Mobile Pentium® II Processor Specification Update

Release Date: February 2000

Order Number: 243887-018

Old Mobile Pentium® II Processor in Mini-Cartridge Package Label with Supplier Matrix Mark

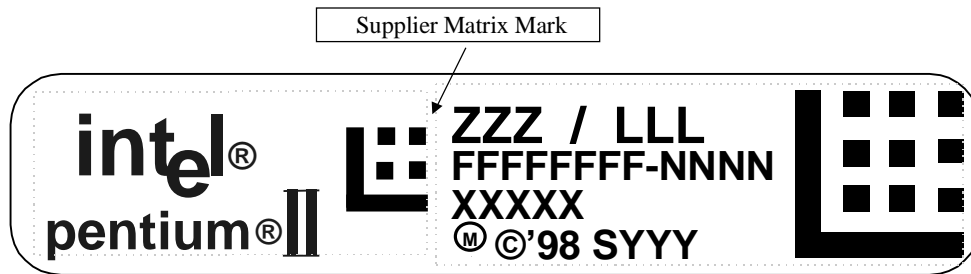
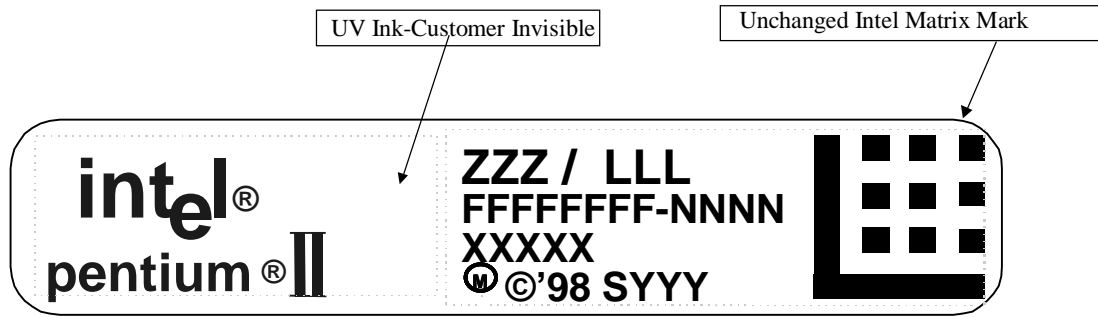
New Mobile Pentium® II Processor in Mini-Cartridge Package Label with Supplier Matrix Mark Removed

Figure 2. Workaround Flowchart: SMBALERT#-Driven System

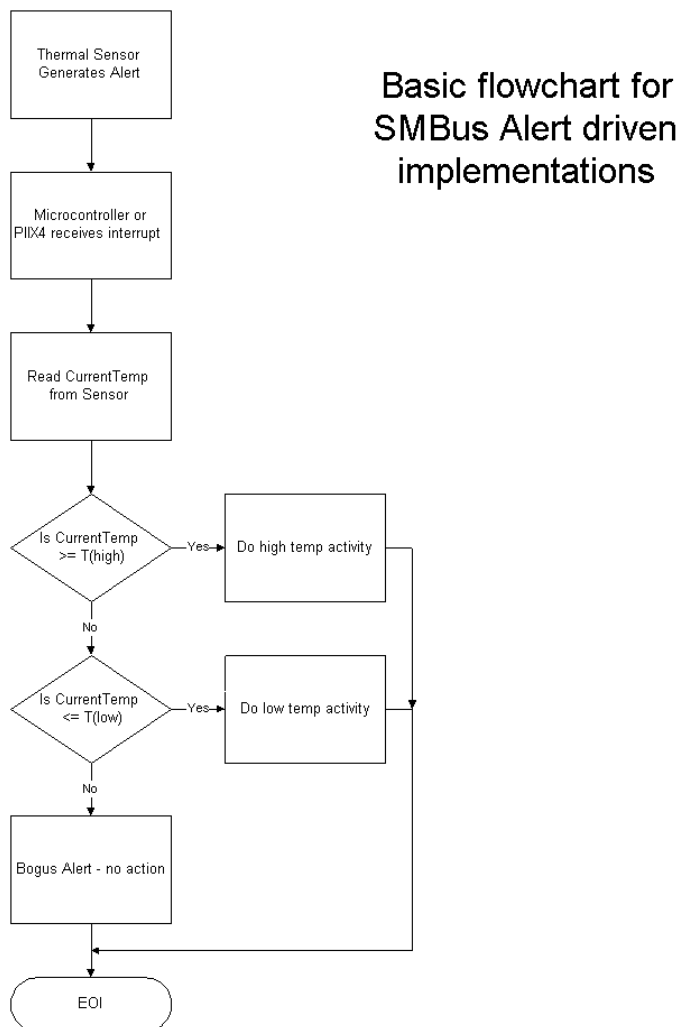
Under the conditions described below, the thermal sensor incorrectly generates the SMBALERT# interrupt. All of the following conditions must be met to trigger a false interrupt:

1. Before servicing an interrupt from the thermal sensor, read and compare the processor thermal reading with the threshold limits (T_{HIGH} or T_{LOW}). Figures 2 and 3 provide basic flowcharts for the implementation of this workaround in an interrupt driven system.
2. If the firmware implemented polls the Status Register only, then before taking any action, re-read the temperature register and do a comparison with the alarm threshold limits (T_{HIGH} or T_{LOW}) to determine if the value is actually still within the temperature window.

Figure 3. Workaround Flowchart: SMI#-Driven System

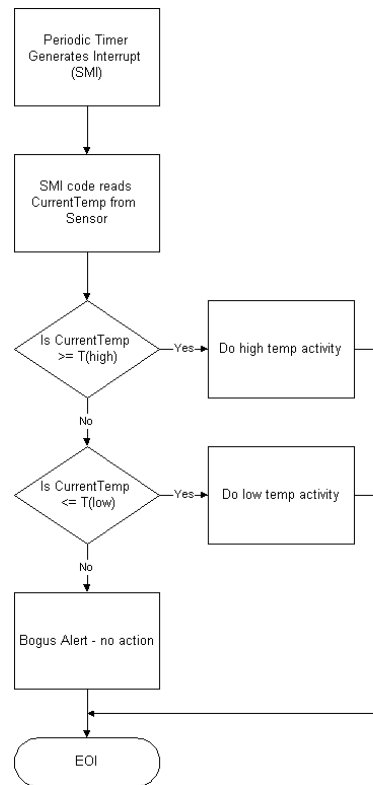
3. Use a temperature polling scheme to monitor the processor temperature.

Figure 5.6. Cross Sectional View with Vertical Dimensions

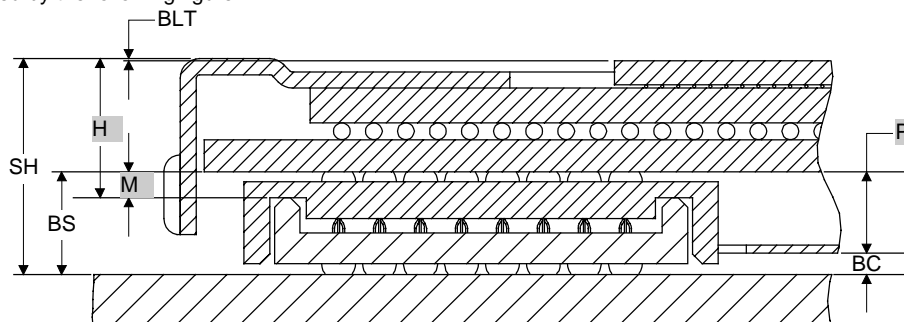
B1. Misabeled Vertical Dimension Parameters

Figure 5.6 in the *Mobile Pentium® II Processor at 233 MHz, 266 MHz, and 300 MHz* datasheet should be replaced by the following figure:

Figure 5.3. Surface-Mount BGA1 Package—Top and Side View

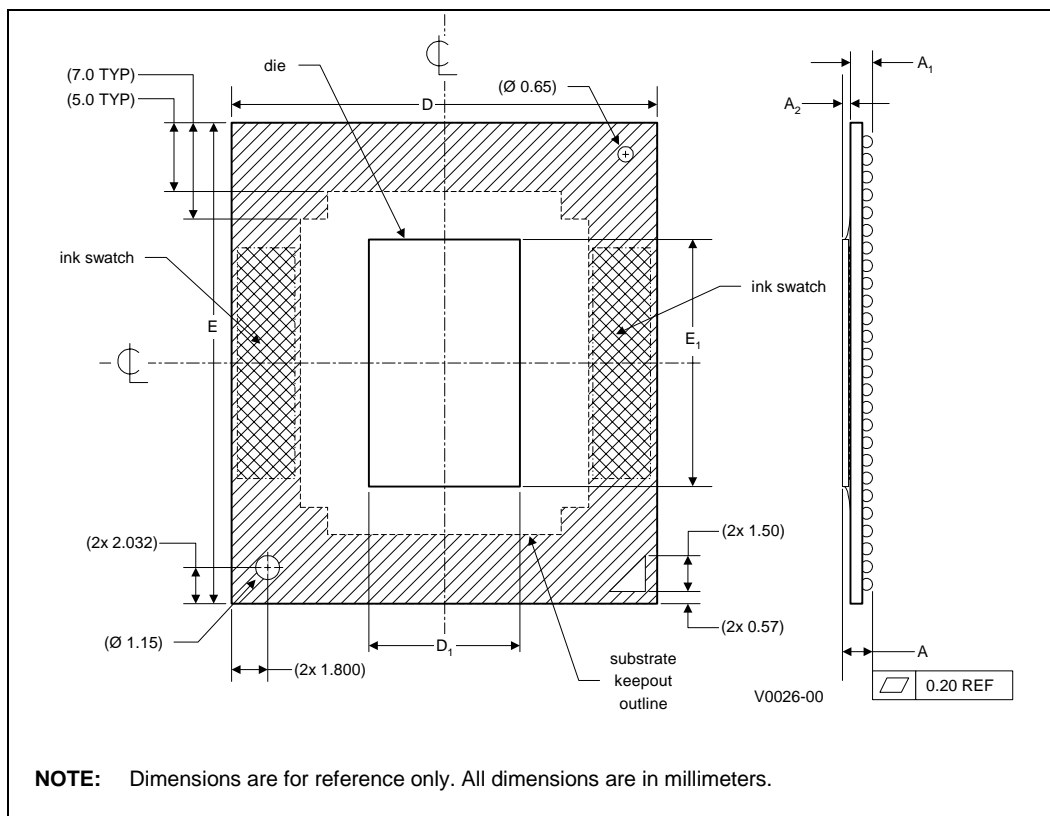
The following table and figures show the updated mechanical specifications for the BGA1 package, listed as Table 5.2, Figure 5.3 and Figure 5.4, respectively, in the *Mobile Pentium® II Processor in BGA Package at 366 MHz, 333 MHz, 300PE MHz, and 266PE MHz* datasheet.

Figure 3.3 Generic Clock Waveform

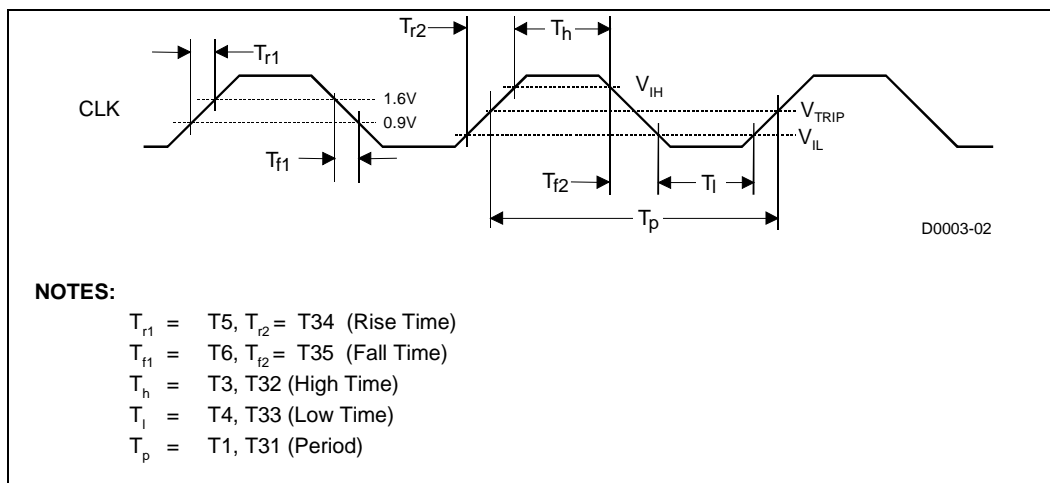
B14. Generic Clock Waveform Figure

Figure 3.3 in *Mobile Pentium® II Processor in Mini-Cartridge Package at 366 MHz, 333 MHz, 300PE MHz, and 266PE MHz* datasheet (Order Number 245108), and the *Mobile Pentium® II Processor in BGA Package at 366 MHz, 333 MHz, 300PE MHz, and 266PE MHz* datasheet (Order Number 245106) has been updated. The following figure is to replace the ones in the above documents.

Figure 1. TAP Gageable Thread Clarification

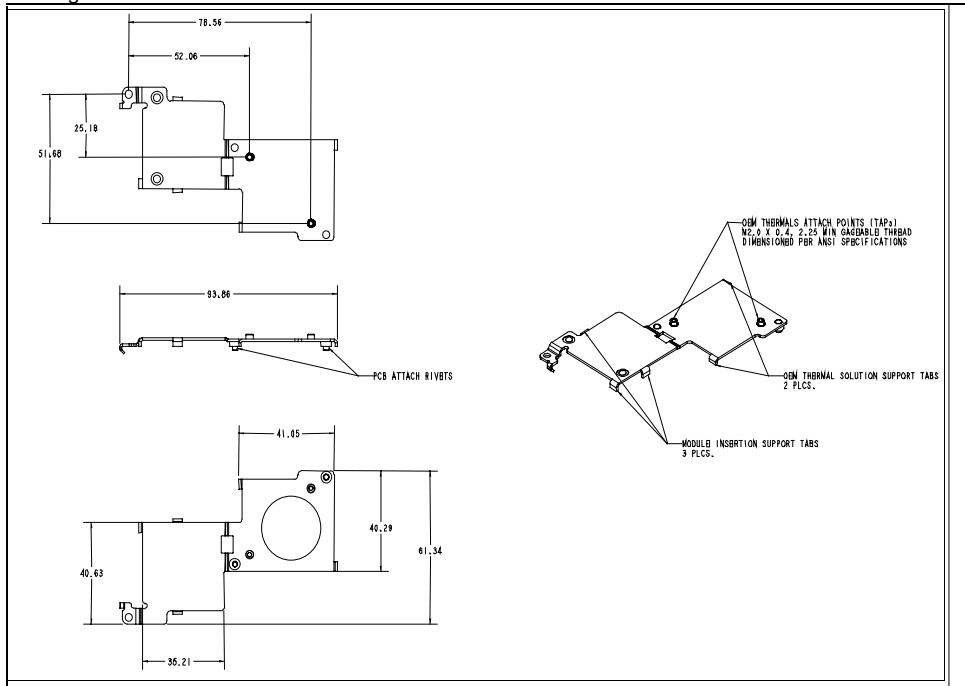
In the *Intel® Pentium® II Processor Mobile Module : Mobile Module Connector 1 (MMC-1)* and the *Intel® Pentium® II Processor Mobile Module : Mobile Module Connector 2 (MMC-2)* datasheets (Order Numbers 243667 and 243668, respectively), the thermal attach point (TAP) gageable thread specification was not clearly identified in Figure 14, of Section 5.2. The following is the TAP clarification:

OEM Thermal Attach Points (TAPs) M2.0 x 0.4, 2.25 min gageable thread dimensioned per ANSI specification.

See Figure 1 below for more information.
